Office Action Summary

10/591,341

OREN ET AL.

2. **Claims 1-8** rejected under 35 U.S.C. 102(b) as being anticipated by **Furusawa (US 2001/0041901)**.

Fig. 19C

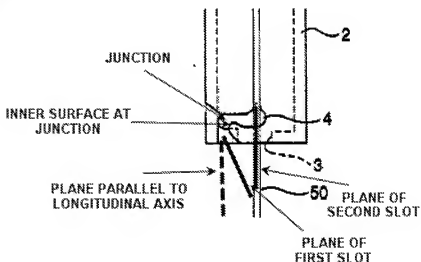
Furusawa discloses an implement for manipulating a knotted suture comprising:
an elongated shaft **2** having a proximal end and a distal end engageable with a knotted suture (FIG 19);
a distal end with a recess **3** for receiving the knot of the suture;
said distal end has an open slot **4, 5** with a first section leading from said recess towards the proximal end and a second section leading from a juncture with said first section towards the distal end but terminating short of the end face. Said first slot section is a three dimensional object and hence has an infinite amount of plane, one of which is in a plane at an angle of 10-30 degrees relative to the longitudinal axis. Said second slot section additionally comprises a plane parallel to the longitudinal axis of the elongated shaft (FIG 19C). The second slot section can be considered leading towards the distal end but terminating short since it widens towards the distal end after the inner surface of the junction. One segment of the plane of said second slot section is rotated

approximately 90 degrees with respect to one segment of the plane of said first slot section (FIG 19A). The slots decrease from said juncture toward the distal since the rounded inner surface of the junction juts out into the slots.
